To: All Canadian Volvo Retailers
Subject: Service Action S19850

| TITLE: Service Action S19850: Securing Wiring Harness (V60) Model Year 2019 V60 | | | | |

QB Instruction VCC-485523-2

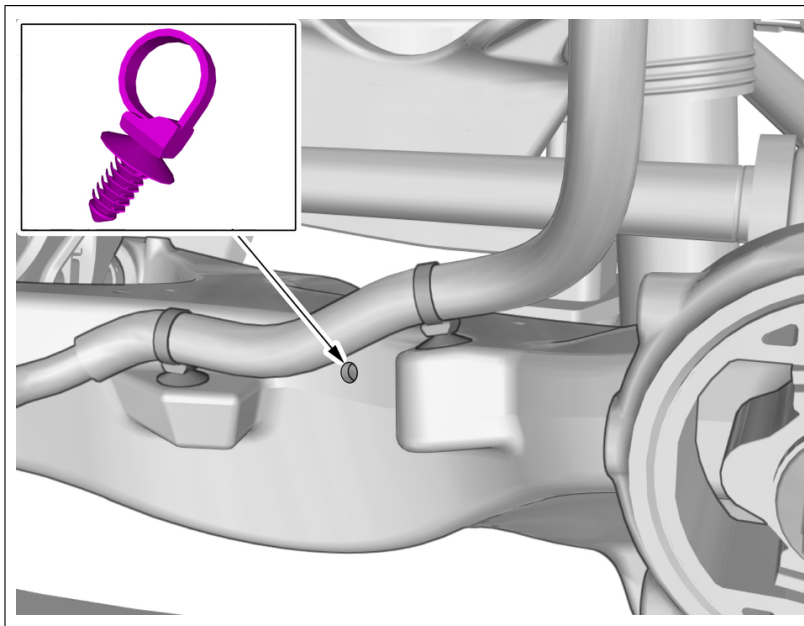
Install the marked component.

On both sides.
